### Denny Terrace Gate Enclosure Solicitation No. 5052

ADDENDUM NO. 1  
Issue Date January 16, 2018

# SK -1: LAYOUT OF DENNY TERRACE GATE & FENCE ENCLOSURE

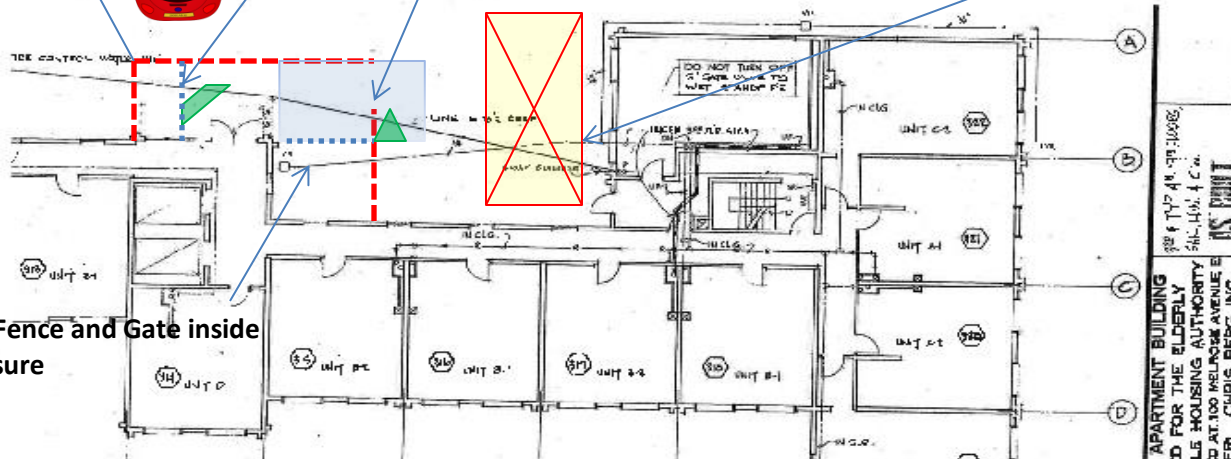
**Item 1.** The following sketch is added to the informal solicitation as referenced in Section 011000 - Summary. Add SK-1: Layout of Denny Terrace Gate & Fence Enclosure.

**SOW: 105 Foot of Anti-Climb Iron Fence Enclosure / New Chain Link Fencing and Gates within Anti-Climb Enclosure / New Pneumatic Closer / New Push to Activate Button / Electrical coordination to install New Phone Entry / New Video Monitor**

**New Chain Link Fence and Gate inside  
New Gate Enclosure**

**New Corrugated Metal Canopy  
abutting existing concrete canopy**

**SHA to Relocate One (1) H/C Parking Space**

**New Chain Link Fence and Gate inside  
New Gate Enclosure**
